Title: Permit Application 20-071: 4512 North Ave, Edina

Recommendation:

MCWD staff recommend denial of the variance to Section 3(a) of the [Floodplain Alteration Rule](#).

Attachment 1: Illustration of Proposed Fill Area

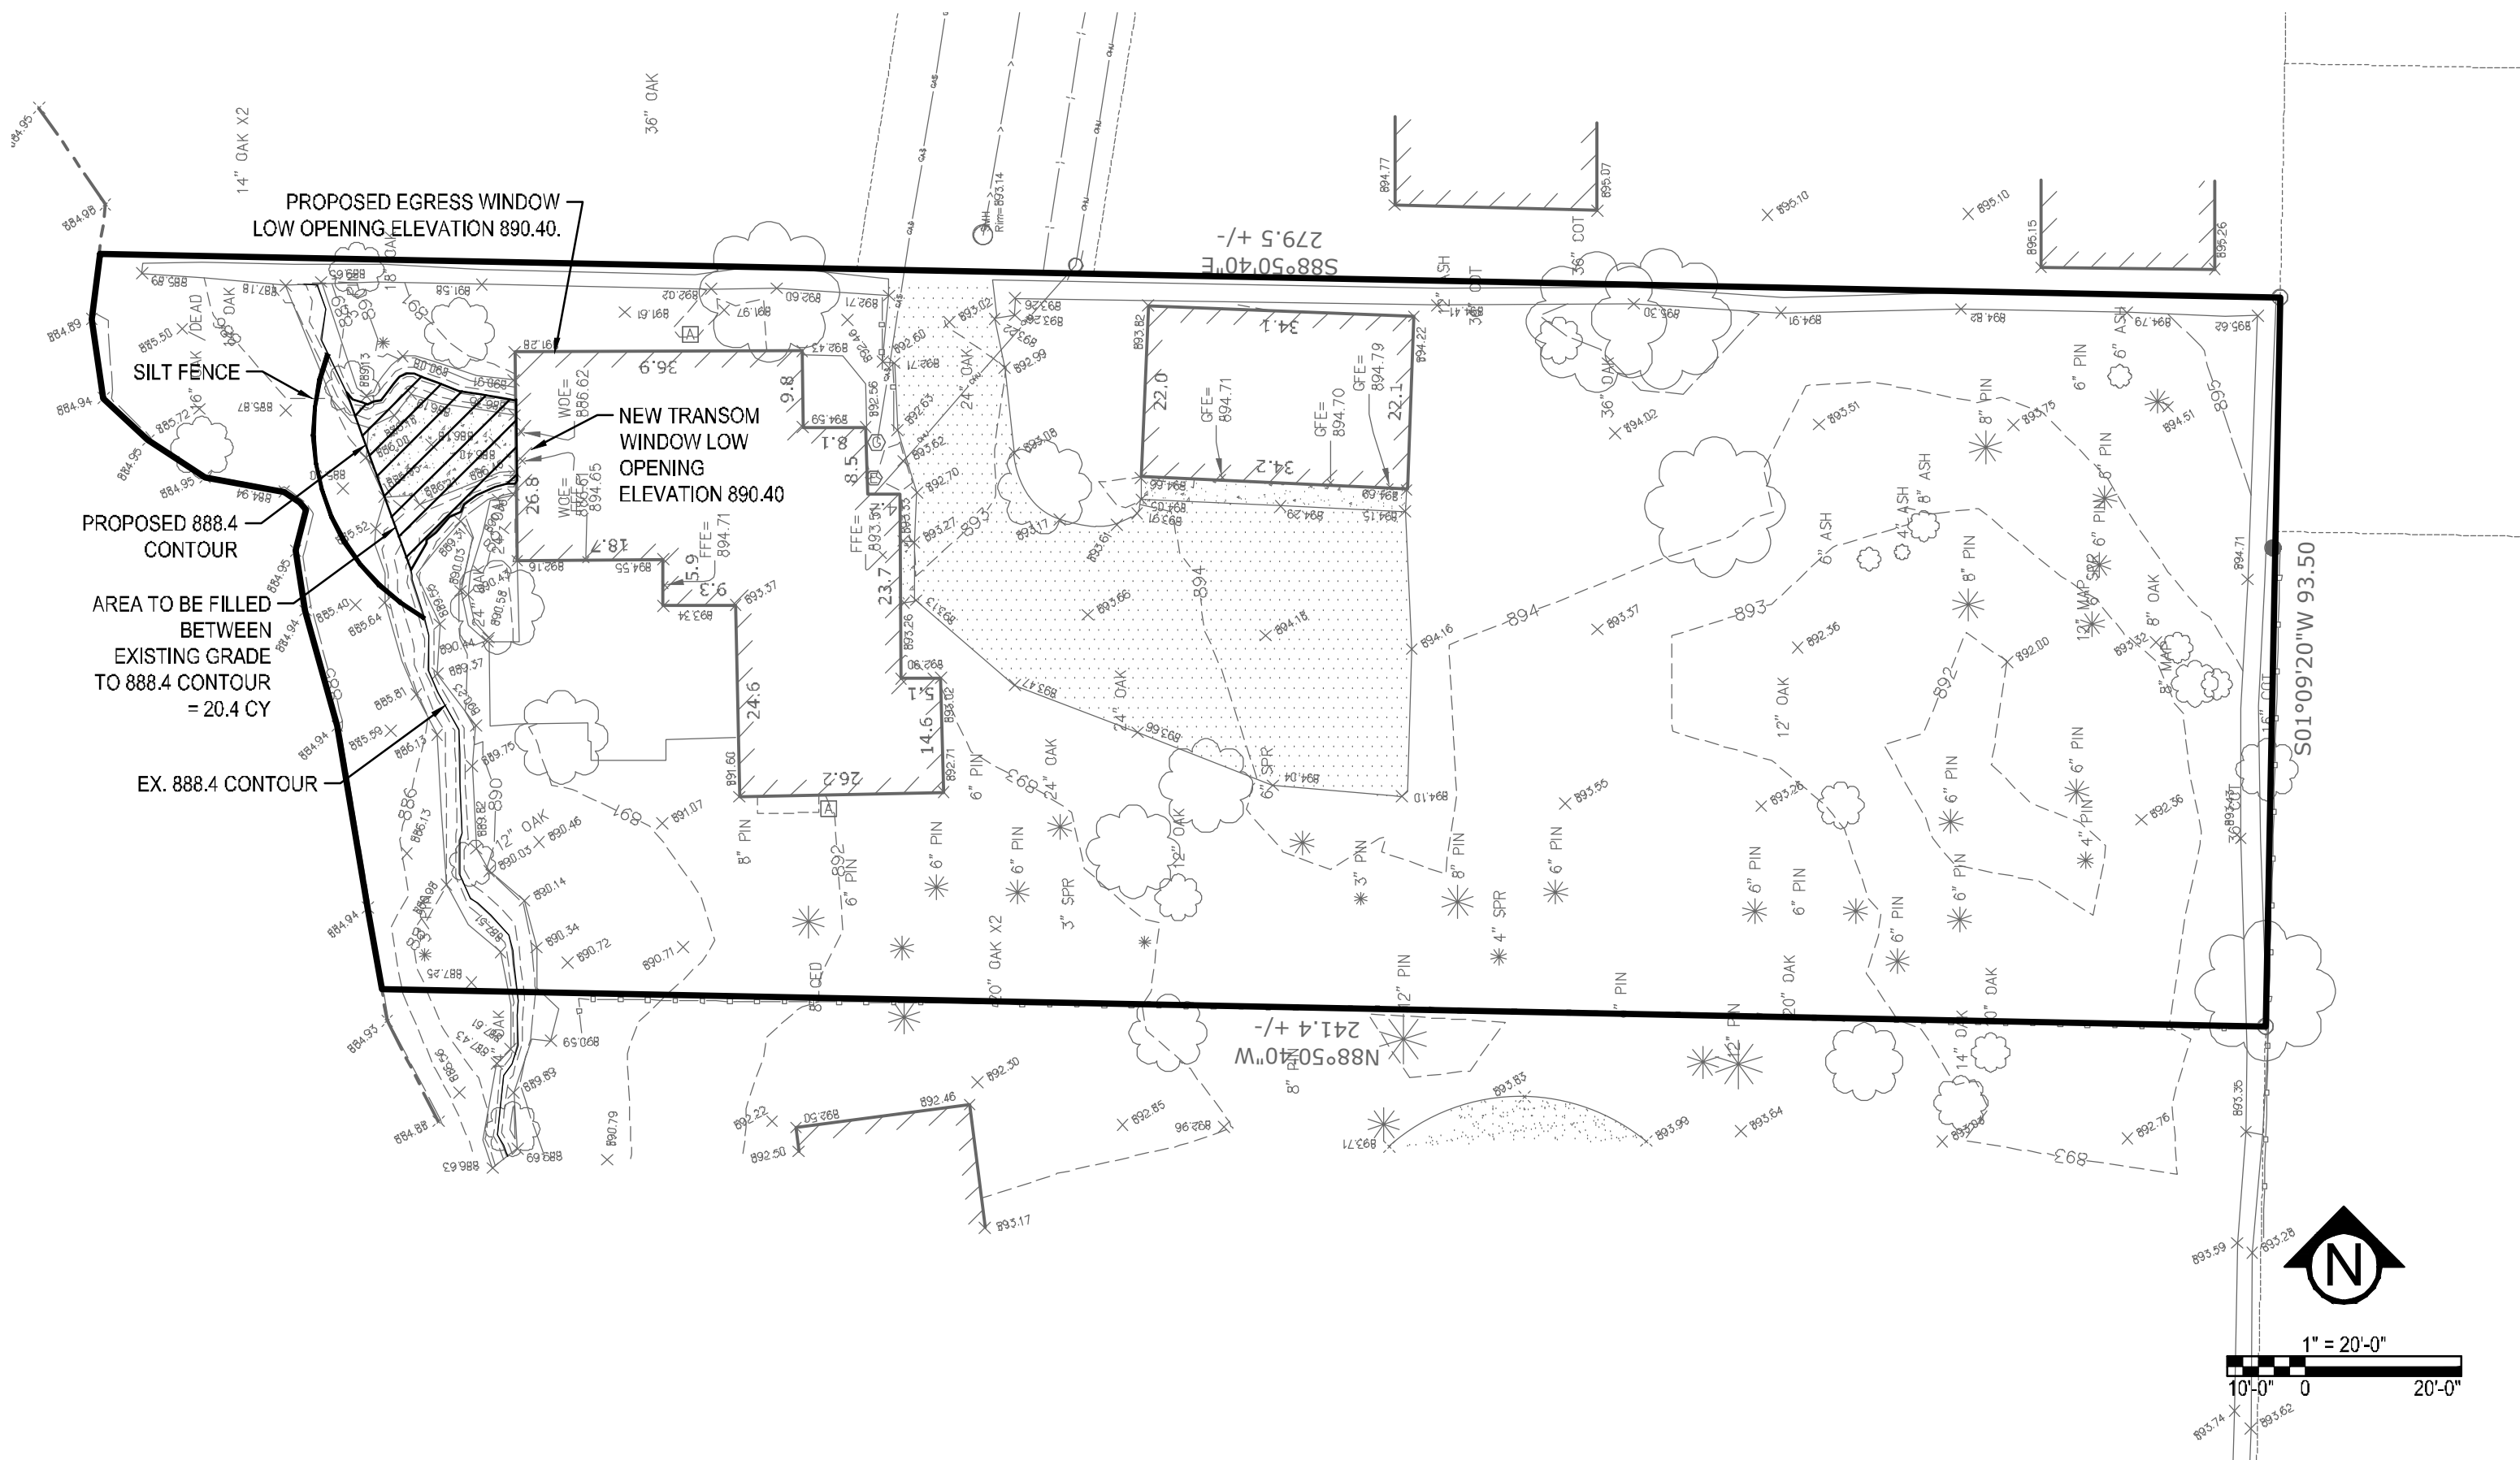
The Applicants are proposing to fill 20.4 cubic yards of the Minnehaha Creek floodplain without providing compensatory storage. Per the District Engineer's analysis (attachment 5), the proposed fill will cause a decrease in floodplain storage capacity at the site.

The District Engineer has identified that it is feasible to construct compensatory storage on site, while preserving the existing single family use of the property and achieving the stated project objectives of reducing flood risk associated with the current walkout. Absent a finding of hardship, a variance cannot be granted.

The District Engineer has reviewed the materials and alternatives submitted by the Applicant, as outlined in the attached memo (attachment 5), and found that there is a technically feasible and prudent alternative to the variance request, which fully complies with the requirement to provide compensatory storage, and, in the District's view, preserves the use of the property and meets the objectives of the project to manage flood risk through the removal of the walkout.

EXHIBIT A

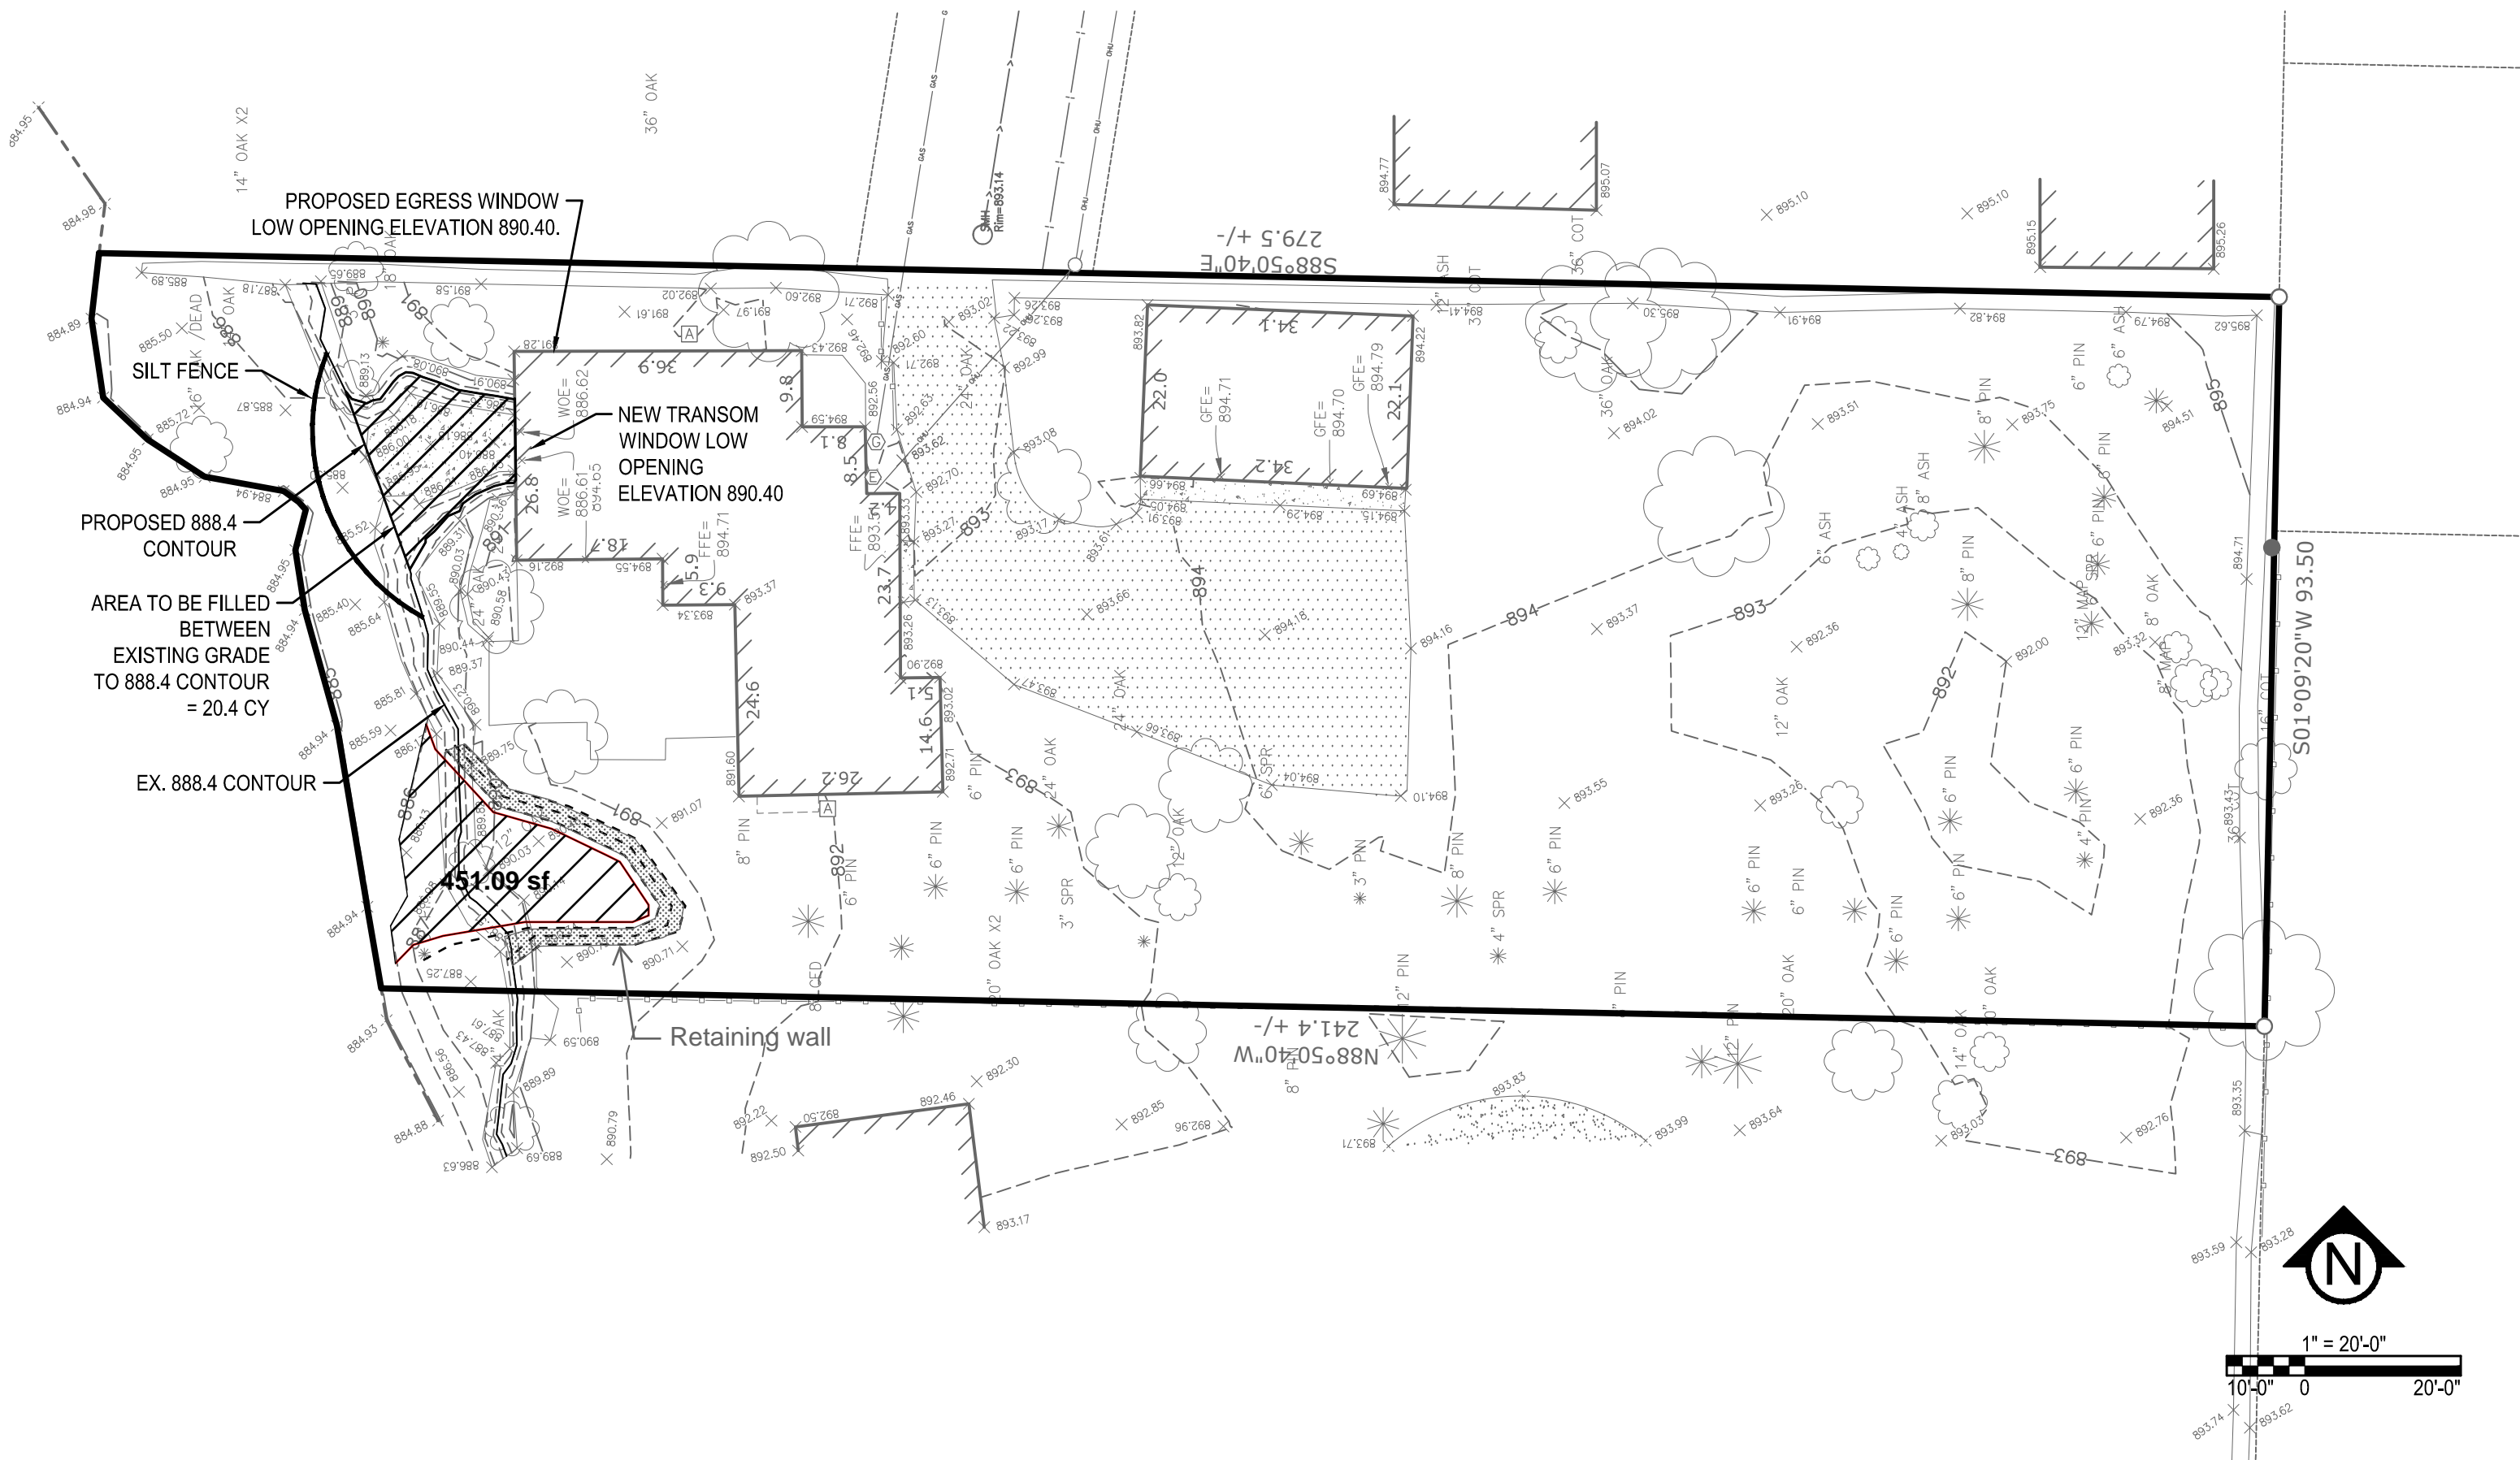
ALTERNATIVE 1 - Excavation of a portion of the yard and retaining wall and converting to floodplain. The limits of this option are shown on **Exhibit B**. Excavation of the upland portion of the yard and converting it to a floodplain as mitigation for the filled portion is not feasible because it would bring flood waters closer to the existing structure on the subject property as well as existing adjacent homes adding flood risk. The north side of 4512 North is very close to the neighbor's home (4508 North) which is vulnerable to flooding of it's basement due to dirt crawlspaces being located on both sides of it's foundation. This was discussed at the MCWD meeting on 1/15/20 and Tom Dietrich agreed then that this aspect was a mitigation issue. These dirt crawl spaces are below the flood elevation of the creek. This mitigation option would also reduce the flood separation to the adjacent property from 30 feet to 10 feet and only provides 10' of horizontal separation to the existing house. Also, mitigation in this area would only yields 10 cubic yards of material and creates a disturbed area of 590 square feet. Any design solution should not be implemented if it increases risk to an upstream or downstream property. Therefore, mitigation on the north side of the lot is not feasible and prudent.

ALTERNATIVE 2 – Excavation of the lower portion of the shoreline on the creek side of the granite retaining wall to approximately 5' from the bottom of the existing granite retaining wall. The limits of this option are shown on **Exhibit B**. Excavation of the upland portion of this area (elevations above 885.30) only yields 3 cubic yards of material. This proposal would also uproot the existing well-established vegetation and disturb the entire frontage of the property a distance of 110 lineal feet and creates a disturbed area of 1060 square feet. Therefore, this option is not feasible and prudent.
